Conceptual Design

Wyoming Blvd Pedestrian Study
Casper, WY

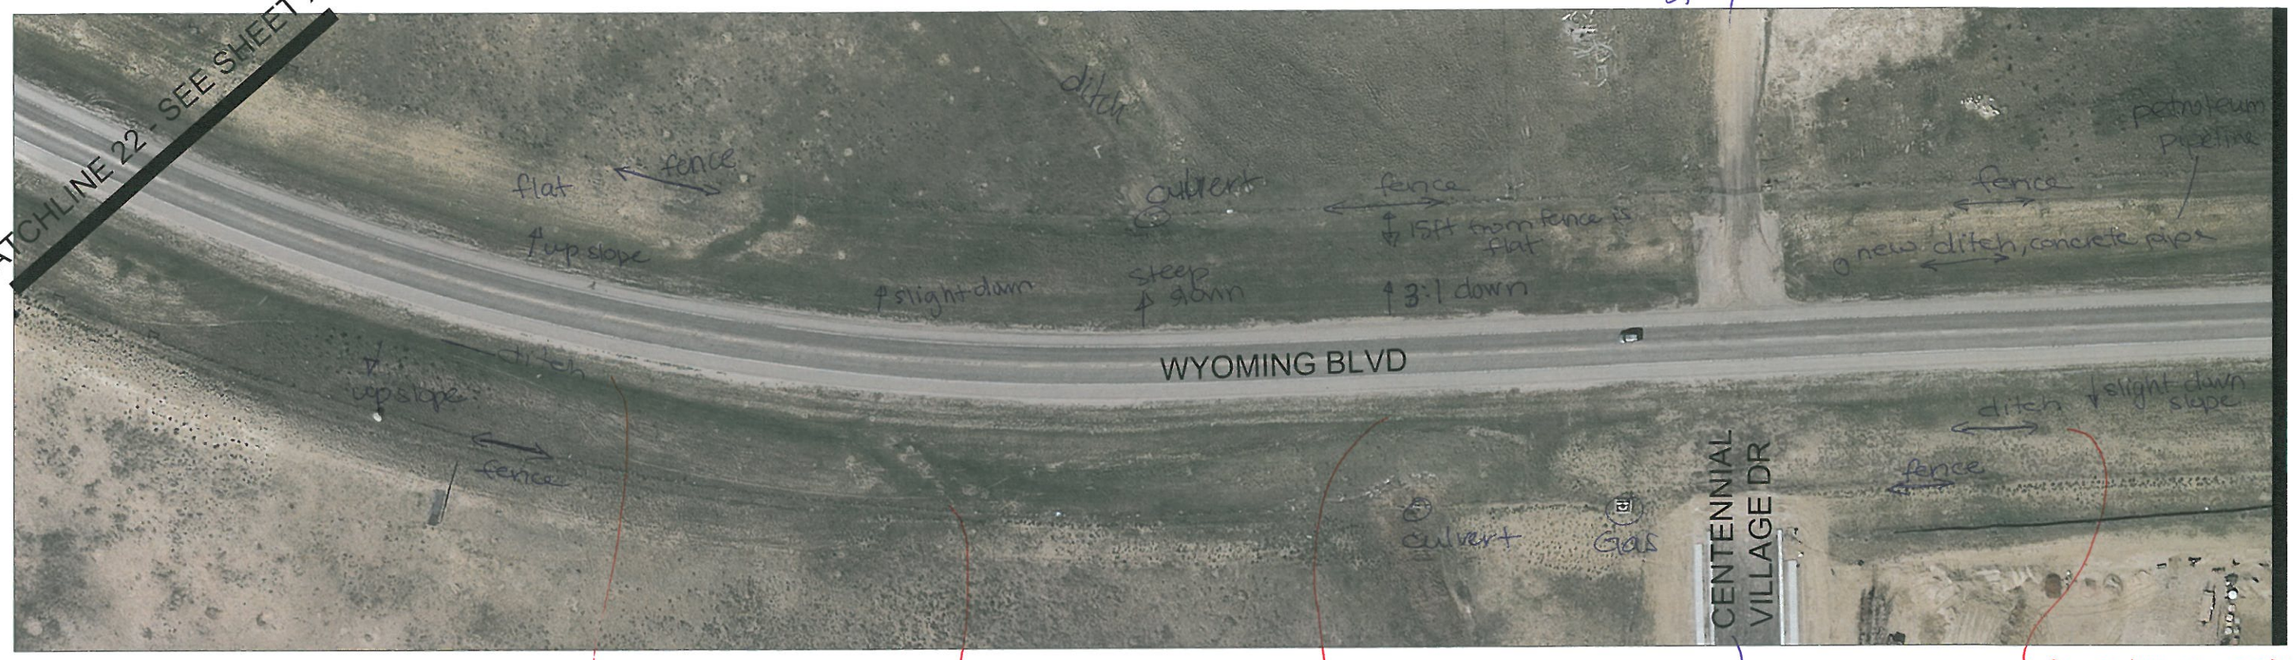
Consider placing trail in ditch

Consider placing trail next to fence

Trail needs to become attach near culvert

Consider running trail along ditch

May need to cut in slope or bring trail up to road or pipe ditch. Consider keeping trail @ middle of hill

Consider placing trail along ditch

- Wide shoulders on roadway
- Opportunities to detach the trail on both sides

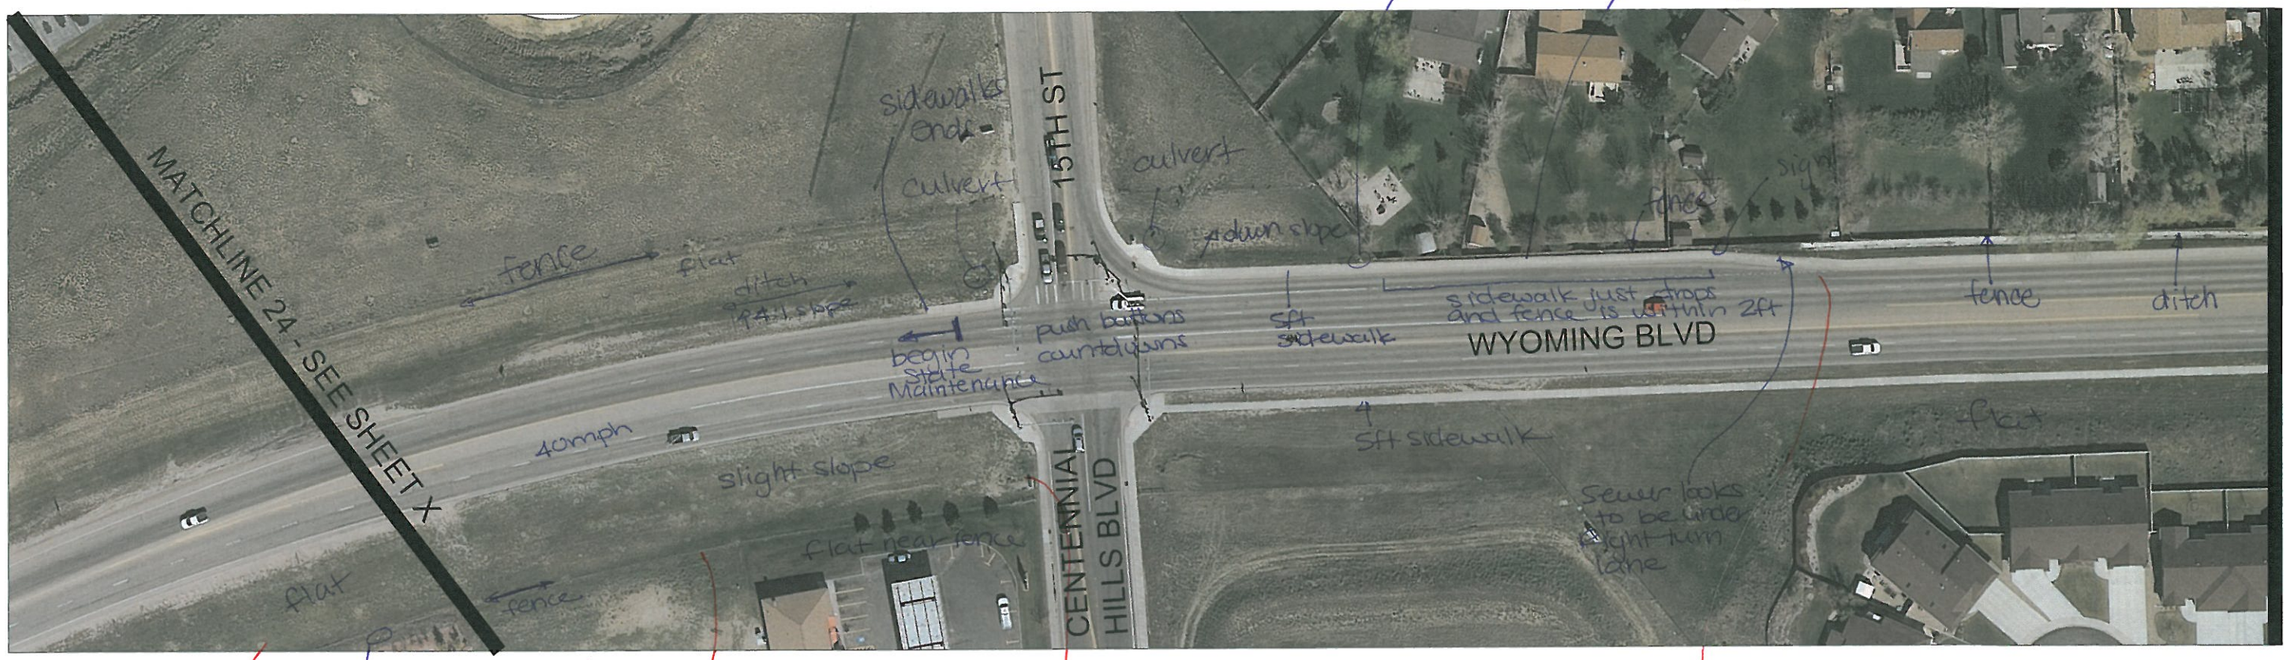
Consider placing trail adjacent to fence

Curve trail in at the intersection

Consider piping entire ditch. Will need ROW to widen sidewalk along Right Turn Lane.

Consider placing trail along the ditch, following the fence line

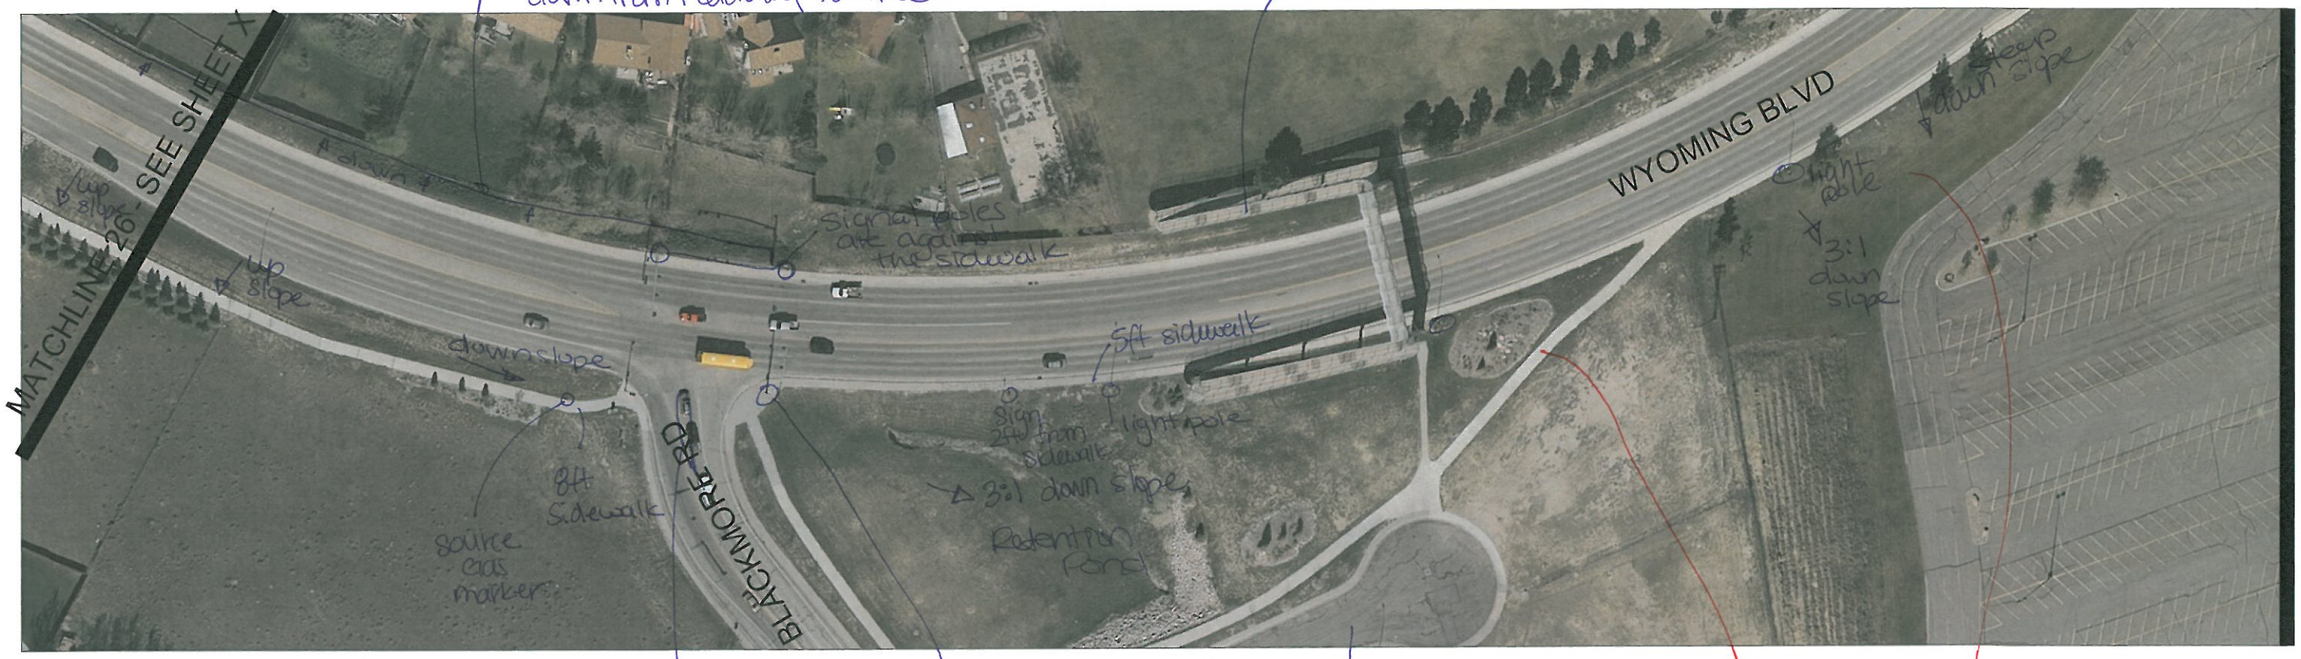
new median with 5ft opening for xwalk
Need to widen to 8feet

Only countdown for N/S on eastside. There are no push buttons. & no xwalks across Wyoming Blvd.

Could divert trail around the ped bridge since attached is limited

Could consider bringing trail down the slope

signal poles near or in sidewalk, narrow curbs

May need retaining wall along this section

Need to fix matchline 27

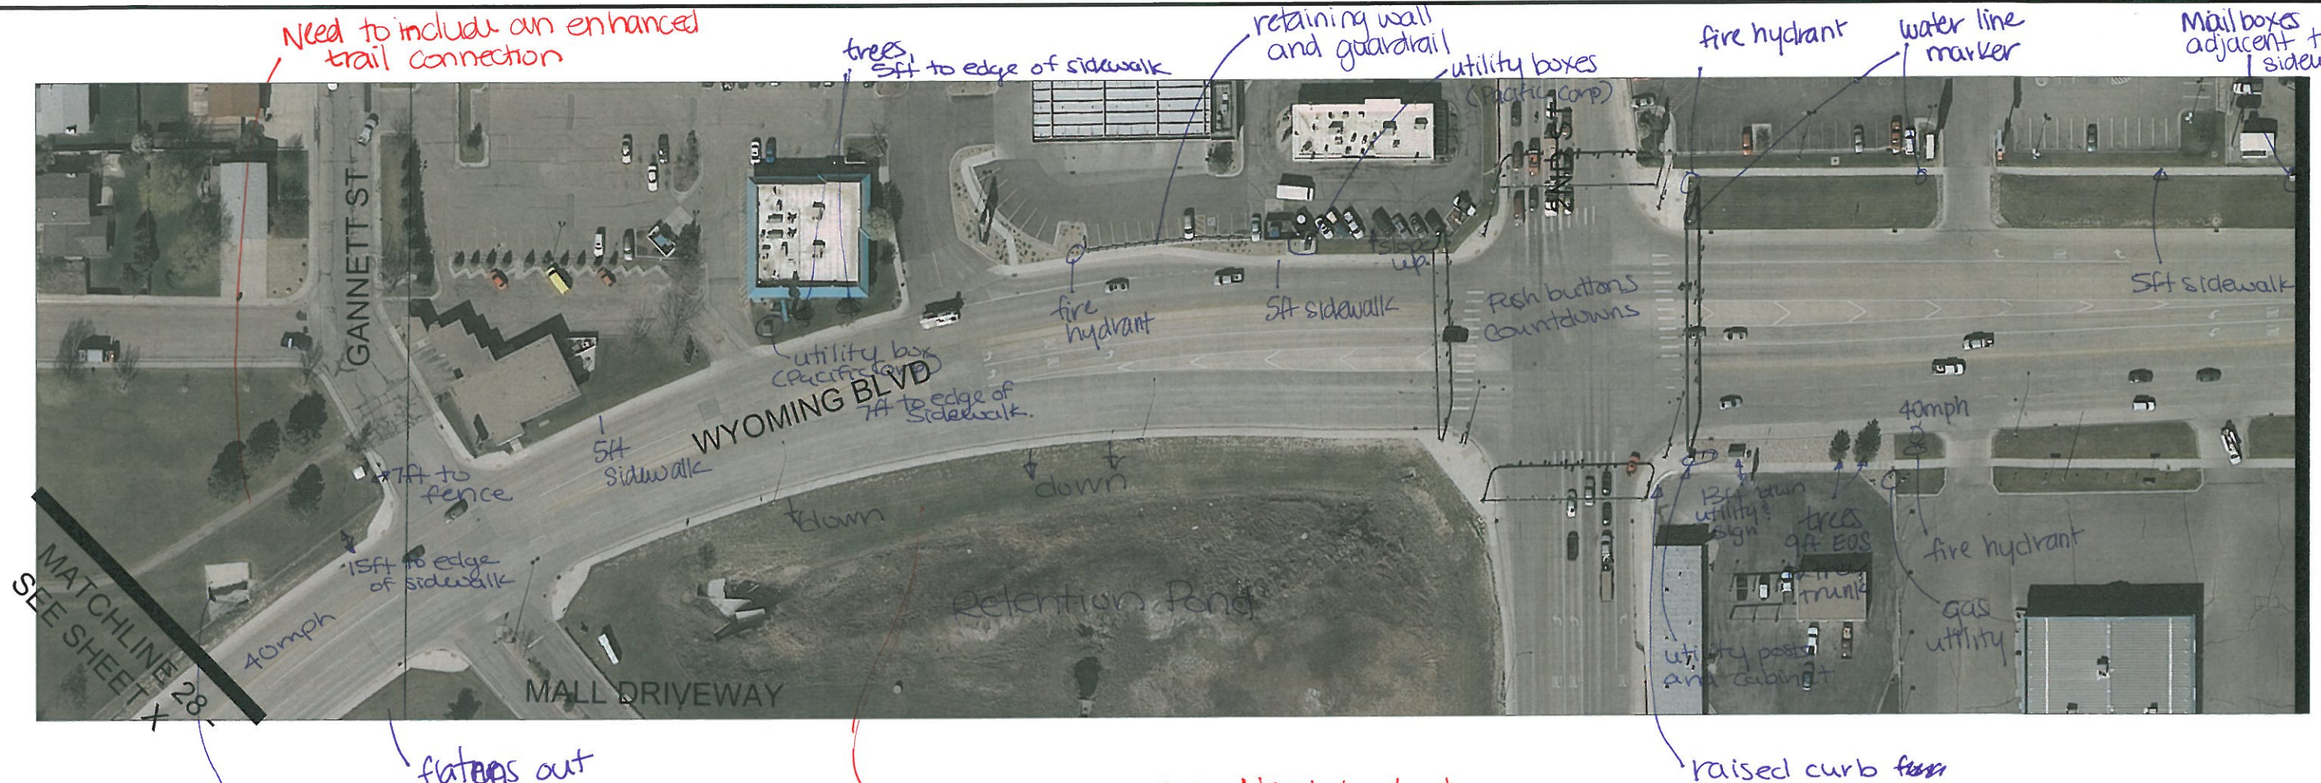
flatten out

May be restrictive. Need to look @ contours and may need to fill if widening sidewalk

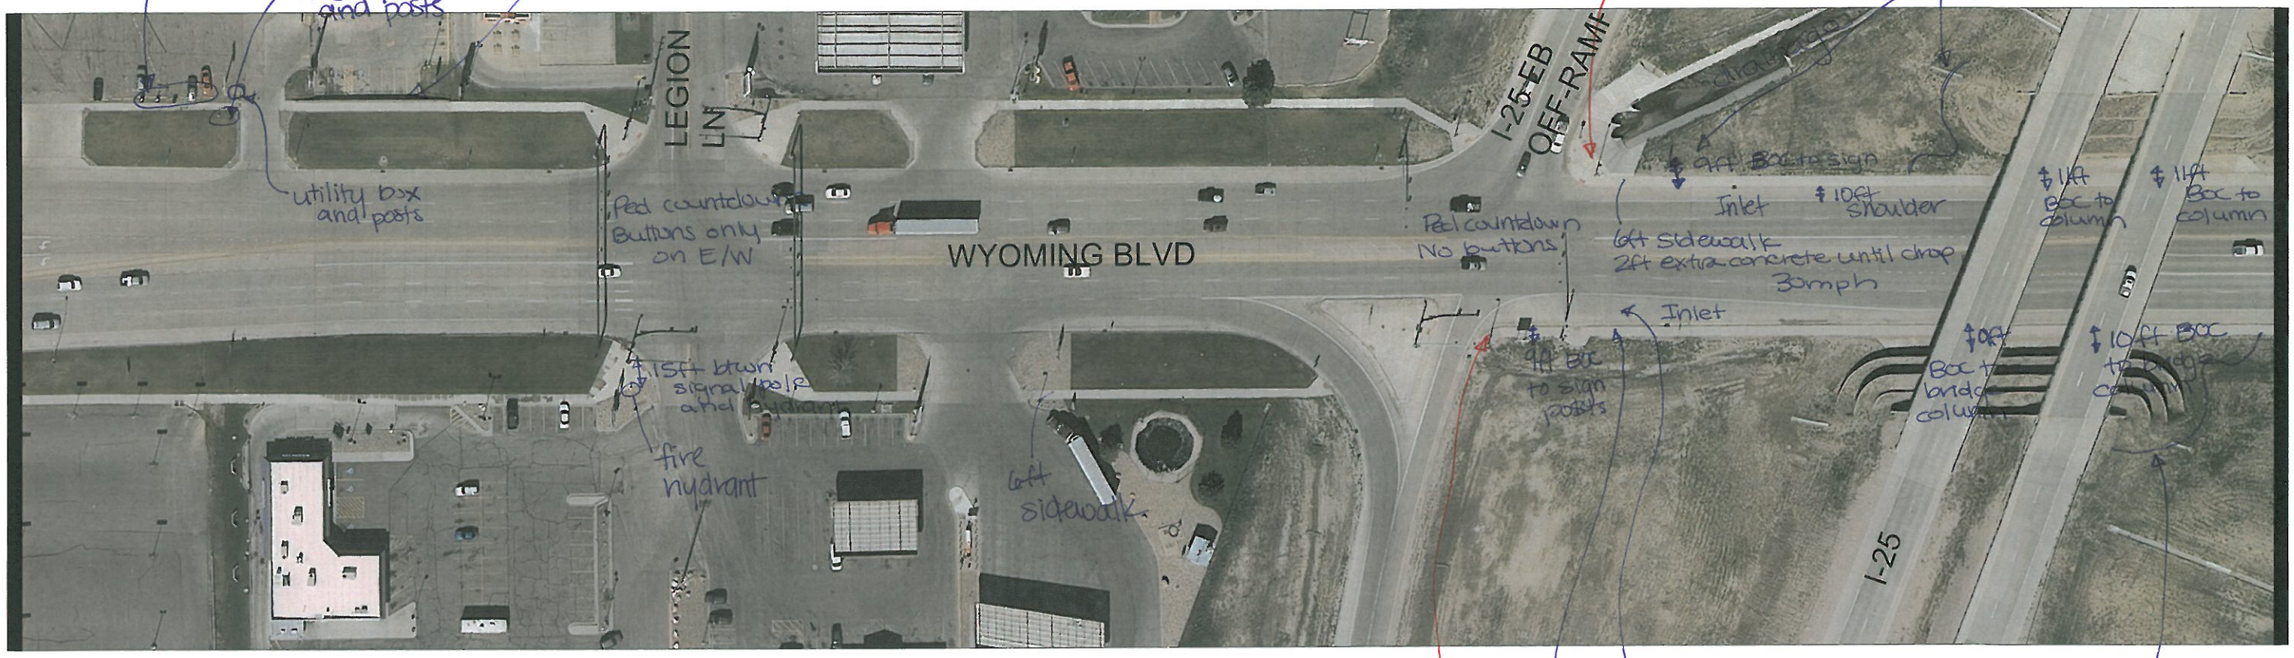
Notes:
- on attached section, could the shoulder be used for additional width?
- there are a few pinch points with signs, columns, hydrant, utility box
-

Notes:
- Pretty straight forward
- Some pinch points with signs, poles
- @ attached portion, there is a very wide shoulder that could be considered for additional width
